Service Technical Information

MODEL NO.	AM-HX50 / HX55
SUBJECT	Come off screw of HP JACK

REF.No. :G – A0 – 011 – E0

DATE :27. APR. 2000

<CONTENTS>

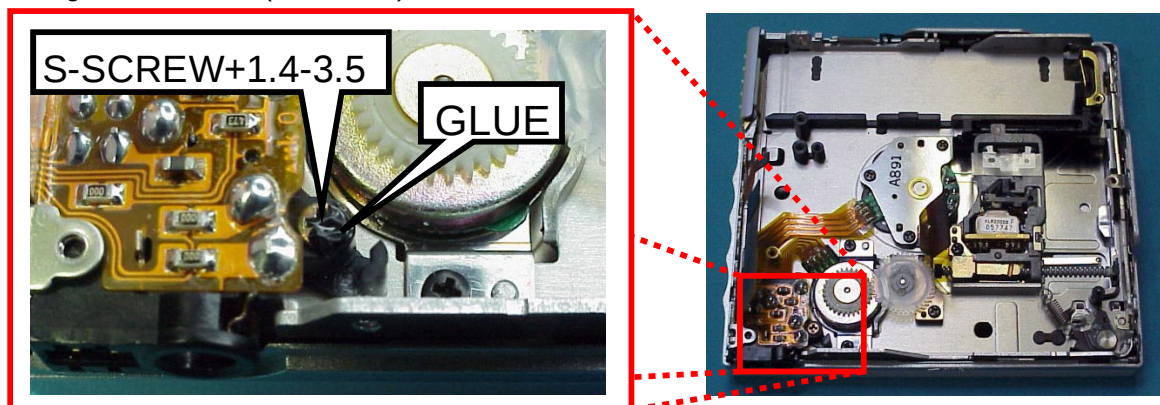
For the above mentioned products, the screw holding the HP JACK are occasionally lost. When this screw dislocate, it attach to the spindle motor or to the magnets of the PICK UP, causing possible NO PLAY.

Complete the following procedures when the screw is missing.

And also complete the following procedures when the screw is taking out during repair.

Replace the screw holding the HP JACK with the Parts Code listed below and glue it on. Use glue No. 1600B(No.1620B).

<NOTE>

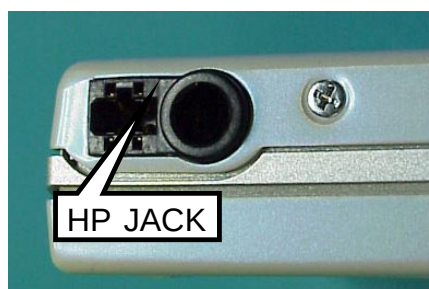
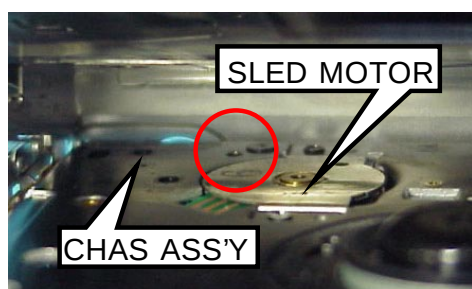
1. Don't fasten too tightly the screw to fix the HP JACK.
 - (1)Be sure that the screw don't protrude from the chassis.
 - (2)Be sure that stress is not applied to the HP JACK.

- 2.Don't get glue on the sled motor or gears.
